Access Compliance Report

Public Rights-of-Way

(Curb Ramps)

Intersection ID: 10635	Main Street: BONAIRE_DR	Cross Street: ENDERLY_RD	Location: S
ADA ID: 4F04A7594304	Ramp Type: Perp	Initial Pass/Fail: Pass	Overall Compliance: No
Severity Score: 0.25			
Codes/Mitigation Info/Possible Solution		Field Measurements/Component Compliance

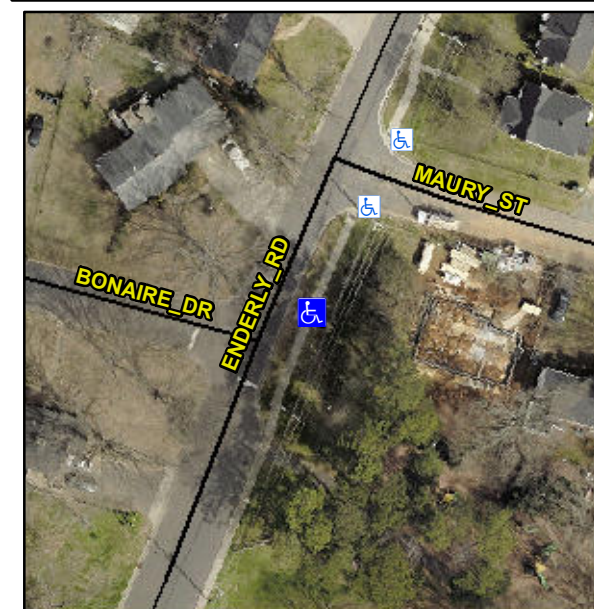
Not Found, R304.5.3, R305.2, R302.7

Compliance	Description	Data	Compliance	Description	Data
N/A	Ramp Length (in)	82.0	Yes	Ramp Slope (%)	7.2
Yes	Ramp Width (in)	59.0	No	Ramp XSlope (%)	4.6
Yes	Flare Type L	Curbed_NoWalkSurface	Yes	Flare Type RT	N/A
Yes	Flare Slope LT (%)	N/A	N/A	Flare Slope RT (%)	N/A
N/A	Flare Traversable LT?	No	N/A	Flare Traversable RT?	No
Yes	Landing Length (in)	60.0	Yes	DWS Provided?	Yes
Yes	Landing Width (in)	71.0	Yes	DWS Contrast?	Yes
Yes	Landing Slope (%)	2.0	Yes	DWS Length (in)	24.0
No	Landing X Slope (%)	7.8	Yes	DWS Full Width?	Yes
N/A	Landing Curb? (Y/N)	No	No	DWS Offset (in)	6.0
N/A	Shared Landing?	No			
No	Gutter Ponding?	Yes	Yes	Gutter Slope (%)	3.3
Yes	Gutter Lip Ht (in)	0.0	No	Gutter X Slope (%)	5.9
N/A	Painted X Walk1?	No	N/A	Painted X Walk2?	N/A
	X Walk 1 Direction	To W		X Walk 2 Direction	N/A
N/A	X Walk 1 Width (in)	N/A	N/A	X Walk 2 Width (in)	N/A
	X Walk 1 Slope (%)	6.0		X Walk 2 Slope (%)	N/A
	X Walk 1 X Slope (%)	1.2		X Walk 2 X Slope (%)	N/A

N/A	Ramp inside XWalk1?	N/A	N/A	Ramp inside XWalk2?	N/A
	Road Slope (%)	N/A	N/A	Clear Space?	Yes
	Road X Slope (%)	N/A	N/A	Clear Space to XWalk (in)	N/A
Yes	Any Obstructions?	No	Yes	Storm Grate/Utility Hazard?	No
	Obstruction Type			Storm Grate/Utility Type	
		N/A			N/A
			Yes	Surface Condition? (G/P)	Good

**Remove & Replace Entire Ramp.
Remove & Replace Gutter.**
